# Peer Review of NMFS's Updated Guidance for Assessing the Effects of Anthropogenic Sound on Marine Mammal Hearing: Underwater and In-Air Thresholds for Onset of Auditory Injury and Temporary Threshold Shifts (Updated Technical Guidance)

## Peer Review Report

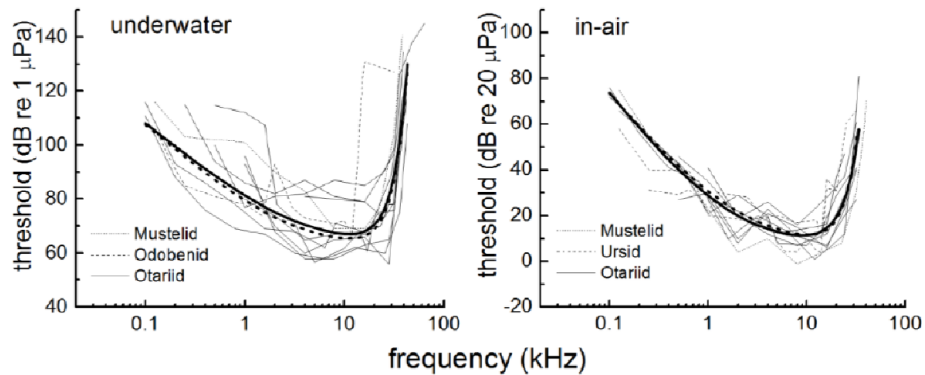
**Comment 49:** [Regarding Table 2 \*footnote] How much of a difference does the inclusion of these data [the otariid pinniped (in air) hearing group’s composite audiogram contains data from a single sea otter (*Enhydra lutris nereis*) from Ghoul and Reichmuth 2014 and five polar bears from Owen and Bowles 2011] make in the composite audiogram? This may be useful

information to include here, especially if it makes a considerable difference, as these other data are not necessarily representative of otariids.

**Response:** A separate U.S. Navy Technical Report (DoN 2017) specifically addressed the Reviewer's comment. Below is a figure from this 2017 report, in which the right side of this figure provides a comparison between mustelid, ursid, and otariid hearing thresholds in-air. In this figure, the thick line represents the composite for all species (mustelids and ursids) in the OA pinniped hearing group, while the dashed line represents just otariids. The inclusion of mustelid and ursid audiogram data does not appear to make a considerable difference to the composite audiogram for OA pinnipeds.
